Contract #: 04-0120F4
 Cty: SF/ALA Rte: 80 PM: 13.2/13.9
 File #: 69.25B

QUALITY ASSURANCE -- NON-CONFORMANCE REPORT

Report No: NCR-000476

Reference Description: Missed UT indications by QC on 1AAW/1AW Segment Transverse Splice

Welding	Concrete	Other	
Welding	Curing	Procedural	Bridge No: 34-0006
Joint fit-up	Coating	Other	Component: 1AAW to 1AW Deck Panel Weld Splice OBW1-001
Procedural	Procedural	Description: Missed UT Indication by QC

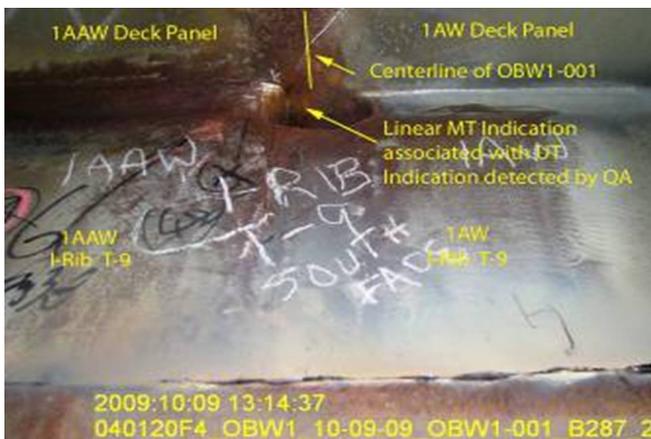
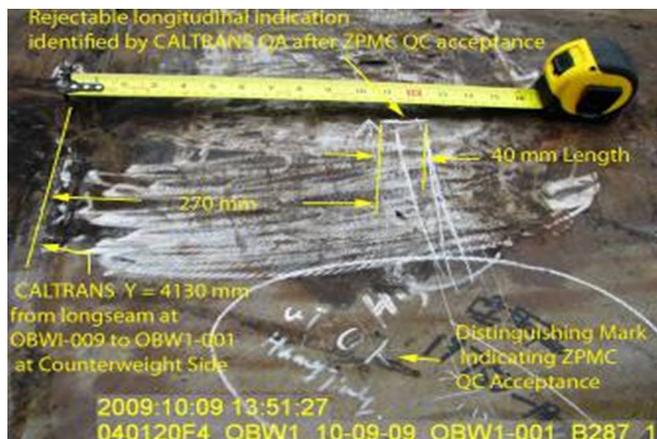
The QA inspector discovered one (1) class "A" rejectable Longitudinal Linear indication in the OBW1-001 (deck panel) weld. This weld was previously tested and accepted by the contractor. This acceptance by the contractor is evident by the presence of the contractor's distinguishing mark indicating QC acceptance. The QA inspector was also able to verify this UT longitudinal indication by magnetic particle (MT) testing from the interior side of the splice weld.

NOTE: The Y location of the Class "A" rejectable Longitudinal Linear Crack is at 5310-5340mm measured from Point W1, or 19750-19780mm if measured from W6. This indication is identified as #25 on ZPMC UT Report B787-UT-8548-1 associated with B-WR7867. The QA inspector verified a 40mm Magnetic Particle (MT) Linear Crack from the interior surface that is associated with Class "A" UT" Rejectable Indication mentioned above.

Submit a repair procedure to the engineer for approval.

Component: Side Panel Segment Splice at 1AAW to 1AW

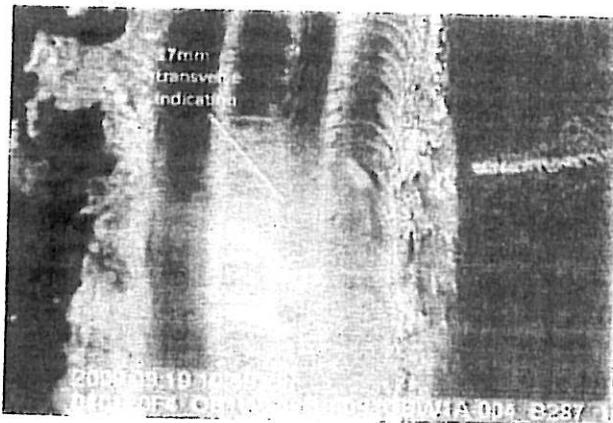
The Quality Assurance (QA) Inspector observed on Sept 18, 2009 and Sept 19, 2009 three (3) visual Transverse Linear Indications in the repair gouges of weld OBW1A-004 (1AAW to 1AW Side Panel Splice at the crossbeam side). The indications were located and documented at Y locations of 5842mm, 6165mm and 6520mm respectively. These visual Transverse Indications were measured from the weld of the Bottom Panel to Side Panel progressing toward the Edge Panel. Subsequently, ZPMC QC performed MT and confirmed that these are transverse indications. This weld joint had been previously tested and accepted by ZPMC QC NDT department.

Propose a resolution for the identified recurring non-conformance which constitutes a systematic problem on both materials/workmanship and quality control issues with revised procedures to remedy the defected work and to prevent future occurrences. A response for the resolution of this issue is expected within 14 days.

Component: 1AW to 1BW Weld #OBW1A-007

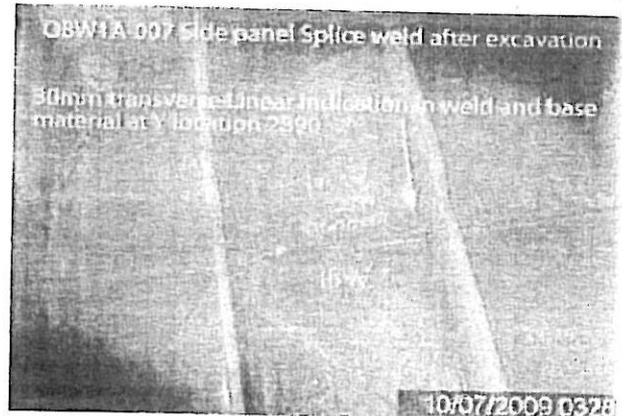
During a random visual observation of ZPMC personnel performing air carbon arc gouging of segment 1AW to 1BW Side Panel transverse splice weld OBW1A-007 at the Counterweight side, the Caltrans Quality Assurance (QA) inspector observed ZPMC was performing this repair utilizing the weld repair report (B-WR8086). This weld repair report did not describe any magnetic particle testing (MT) verifications in the excavation prior to re-welding nor after the completion of welding to ensure that the joint is free of defects. The QA Inspector had the opportunity to perform MT after air carbon arc gouging and observed numerous transverse cracks present ranging from 2 mm to 30 mm in length. No Critical Weld Repair Report was obtained for this weld repair.

The Y locations and the number of Transverse Cracks observed in weld # OBW1A-007:

- 1) Y=50~2475mm, (14) Transverse Cracks
- 2) Y=2720~5030mm, (29) Transverse Cracks

Component: 1AW to 1BW Side Panel Splice Weld OBW1A-007

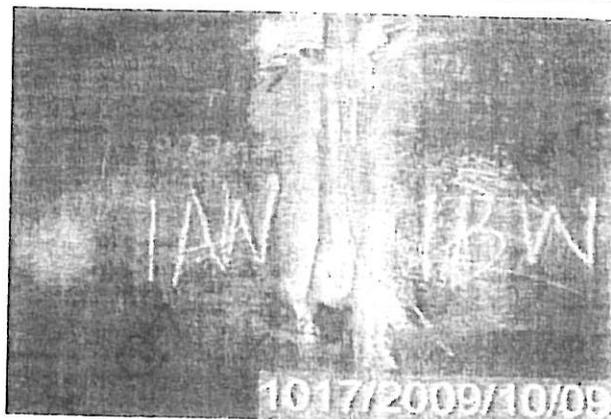
During a random visual inspection of repair work located at 1AW to 1BW side panel segment transverse splice weld OBW1A-007, the Caltrans Quality Assurance (QA) Inspector observed ZPMC workers performing repair excavations at two (2) separate areas along this weld splice. The QA Inspector performed Magnetic Particle testing (MT) at the excavated areas that had been previously tested and accepted by ZPMC MT technician. This QA inspector observed seven (7) Transverse Cracks present in the 2 excavation areas. The submitted critical weld repair procedure (CWR) for this location has not been approved by the Engineer prior to the repair work being started. The Y locations, length of excavated area and number of Transverse Cracks are as followed:

Transverse Weld Splice OBW1A-007

1. Y location 150mm, length of excavation 2,400mm, one (1) indication verified.
2. Y location 760~920mm, length of excavation 2,400mm, three (3) indications verified.
3. Y location 2,650mm, length of excavation 2,300mm, one (1) indication verified.
4. Y location 2,800mm, length of excavation 2,300mm, one (1) indication verified (in 1AW base metal).
5. Y location 3,400mm, length of excavation 2,300mm, one (1) indication verified.
6. Y location 4,600mm, length of excavation 2,300mm, one (1) indication verified.

Submit a repair procedure for the approval of the engineer. Do not start weld repair until the CWR has been approved by the engineer. Missed MT indications have become a chronic problem. Provide training and tests to verify MT technician competency.

Component: 1AAW to 1AW Deck Panel Weld Splice OBW1-001

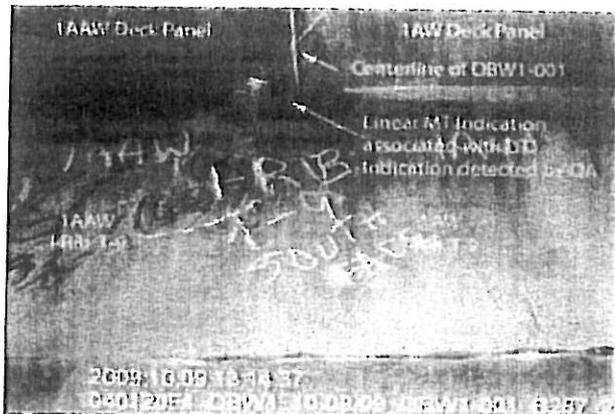
The QA inspector discovered one (1) class "A" rejectable Longitudinal Linear indication in the OBW1-001 (deck panel) weld. This weld was previously tested and accepted by the contractor. This acceptance by the contractor is evident by the presence of the contractor's distinguishing mark indicating QC acceptance. The QA inspector was also able to verify this UT longitudinal indication by magnetic particle (MT) testing from the interior side of the splice weld.

NOTE: The Y location of the Class "A" rejectable Longitudinal Linear Crack is at 5310-5340mm measured from Point W1, or 19750-19780mm if measured from W6. This indication is identified as #25 on ZPMC UT Report B787-UT-8548-1 associated with B-WR7867. The QA inspector verified a 40mm Magnetic Particle (MT) Linear Crack from the interior surface that is associated with Class "A" UT" Rejectable Indication mentioned above.

Submit a repair procedure to the engineer for approval.

Component: 1AW to 1AAW Side Panel Splice Weld OBW1A-00

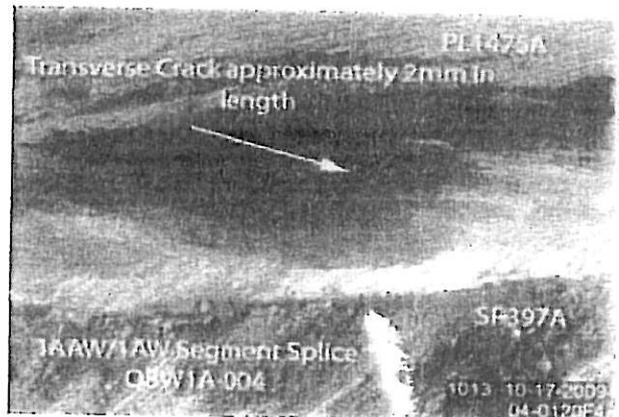
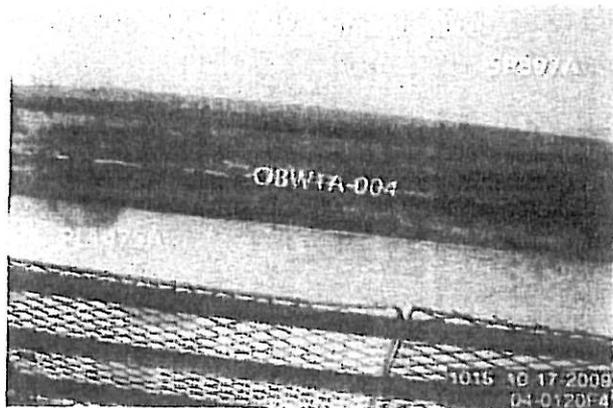
During random visual inspection the QA Inspector performed Magnetic Particle Testing (MT) of an Ultrasonic Testing (UT) reject excavation in the segment CJP Side Plate splice (OBW1A-004), cross beam side joining SP397A (1AW) and PL1475A (1AAW). During this verification the QA Inspector discovered three (3) Transverse Cracks in the excavation. One (1) 2 mm crack was located at Y location 1945mm and two (2) 1mm cracks at Y location 2785mm from the cross beam side Edge Plate.

Submit a repair procedure to the engineer for approval.
